Proposal #20: 9465-00-71, WISC 2019 808
Lincoln County Line – USH 51
S Leisure Dr to S Garth Lake Rd
CTH Y
Oneida County

This is Addendum No. 01, which provides for the following:

ADDENDUM NO. 01

Addendum No. 01
ID 9465-00-71
Revised Sheet 28
January 8, 2020

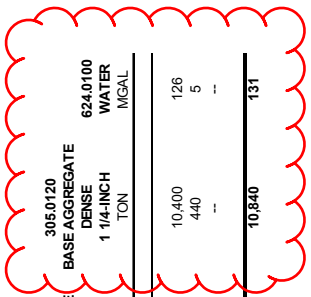
Revised Plan Sheets	
Plan Sheet	Plan Sheet Title (brief description of changes to sheet)
28	Miscellaneous Quantities (Revised mainline unexpanded fill area and borrow quantity.)
29	Miscellaneous Quantities (Revised mainline base aggregate dense 1 ¼-inch and water quantities.)
30	Miscellaneous Quantities (Added Seed Mix No.60 quantity to Landscaping Items.)
31	Miscellaneous Quantities (Revised "For Information Only" Temporary Diversion Channel quantities of geotextile fabric and sand bags.)

From/To Station	Location	Common Excavation (1)		EBS Excavation (Item # 205.0100)	Salvaged/Unusable Pavement Material (4)	Available Material (5)	Unexpanded Fill (CY)	Expanded Fill Factor (13)	Mass Ordinate +/- (14)	Waste (CY)	Borrow (Item # 208.0100) (CY)
		Cut (2) (CY)	Excavation (CY)								
8+00 to 110+50	Mainline N Leisure Dr	1244	0	0	0	1244	6012	7515	-6271	0	6271
		86	0	0	0	86	0	0	86	86	0
Grand Total		1331	0	0	0	1331	6012	7515	-6184	86	6271
Total Common Exc											1331
